**UPDATE TO URGENT FIELD SAFETY NOTICE**  
**Percept™ PC Implantable Neurostimulator (INS) Model B35200 Unable to be Interrogated, INS Failure After Cardioversion and A610 Replacement workflow with DBS Pocket Adaptor affecting MRI eligibility display Software Update**

January 2025

### A610 Replacement workflow with DBS Pocket Adaptor affecting MRI eligibility display

Medtronic Reference: FA1412

Figure 1: A610 Clinician Programmer MRI ELIGIBILITY workflow with red annotations added.

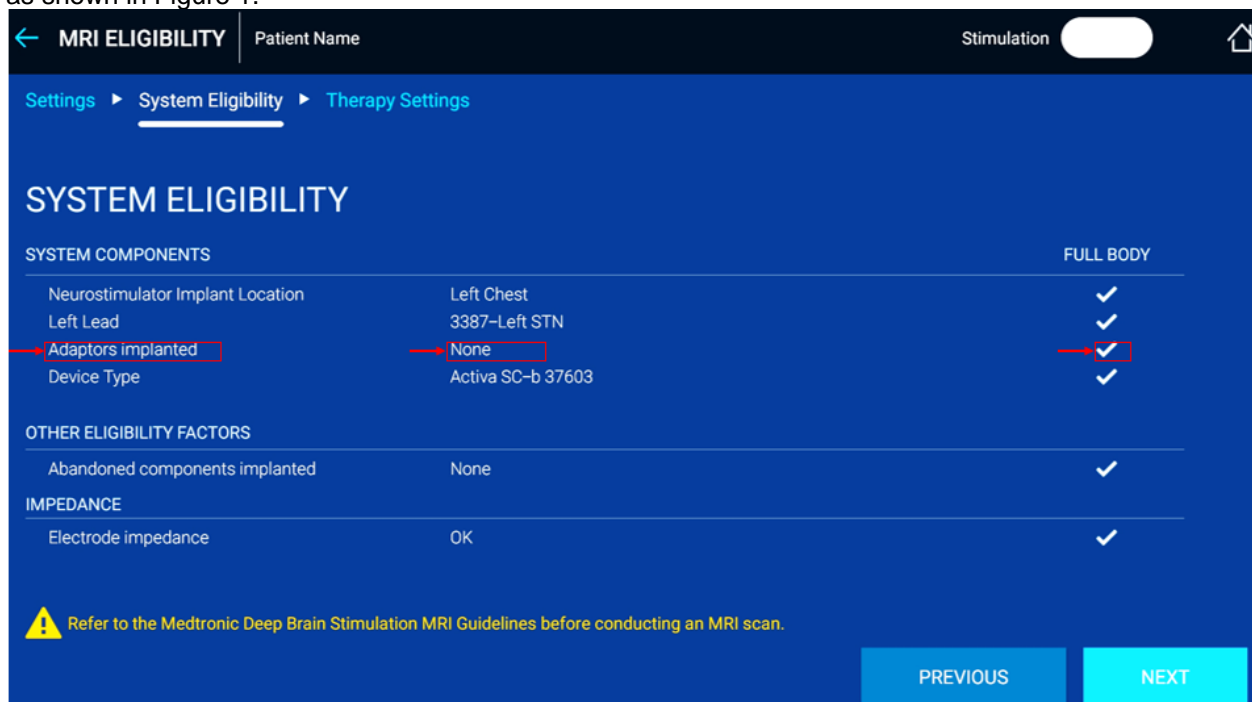
The purpose of this letter is to inform you of an issue related to the Magnetic Resonance Imaging (MRI) Eligibility status displayed in certain versions of the Deep Brain Stimulation (DBS) Clinician Programmer (Model A610) and DBS Patient Programmer (Model A620) applications. Patients implanted with a pocket adaptor (Model 64001 and/or 64002) are limited to "HEAD ONLY" MRI eligibility. With this issue, the clinician and patient programmers may incorrectly display MRI eligibility as "FULL BODY" scan eligible, as shown in Figure 1.

This issue has the potential to result in exposure of the patient to an incorrect MRI (e.g., "Full Body" instead of "Head Only" scan eligibility), which could result in heating at the lead electrode(s) and potential tissue damage. Excessive heating can result in serious or permanent injury including coma, paralysis, and death.

This issue occurs only for those patients with a pocket adaptor and, for reasons related to the A610 "REPLACEMENT" workflow, the programmer does not display a pocket adaptor in the MRI ELIGIBILITY workflow. For patients where the programmer incorrectly displays no pocket adaptor, a pocket adaptor component can be added on the physician programmer SETUP workflow. This will set the "Adaptor implanted" status to "Yes" and lead to automatic correction of the MRI eligibility display. Detailed instructions are provided below. If the programmer does display a pocket adaptor, no further action is needed.

1. To check if a patient has an implanted pocket adaptor, review your patient's medical records and determine if they have an implanted pocket adaptor with INS Models Activa™ SC 37603, Percept™ PC B35200, or Percept™ RC B35300.
2. For every patient identified, use the A610 CP application MRI ELIGIBILITY workflow to determine the status of the 'Adaptors Implanted'. Note that the patient will need to be in the clinic for this step.

Figure 2: A610 Clinician Programmer MRI ELIGIBILITY workflow with red arrow pointing to "Adaptor implanted" status.

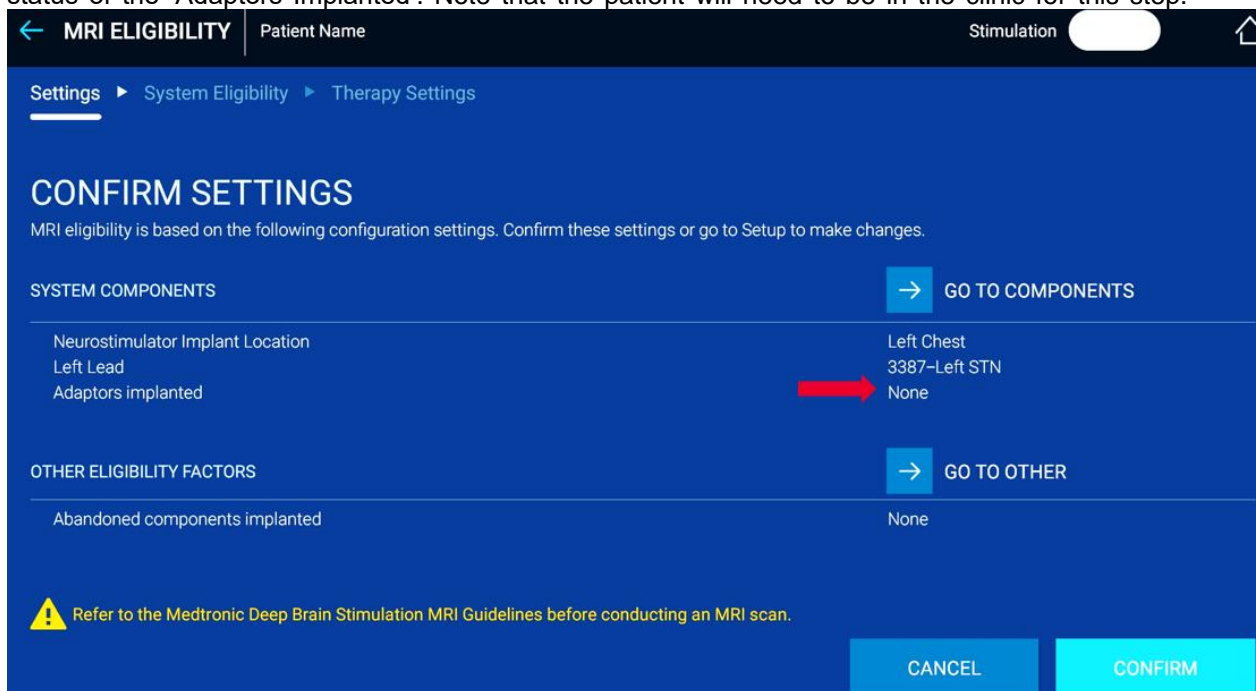
- 2.1. If the status is 'Yes,' no further action is needed. This confirms the clinician programmer and patient programmer applications will display the correct MRI eligibility for that patient.
- 2.2. If the status is "None" or "?" (Figure 2), follow steps 3 to 5 to revise the status of MRI eligibility on the programmer. Once these steps are completed, both the clinician programmer and patient programmer applications will display the correct MRI eligibility for that patient.

- Obtain the current stimulation settings (i.e., via a session report) as you may be required to re-enter them.
- Go to the SETUP workflow on the Clinician Programmer to determine if the pocket adaptor is shown in the Components screen.
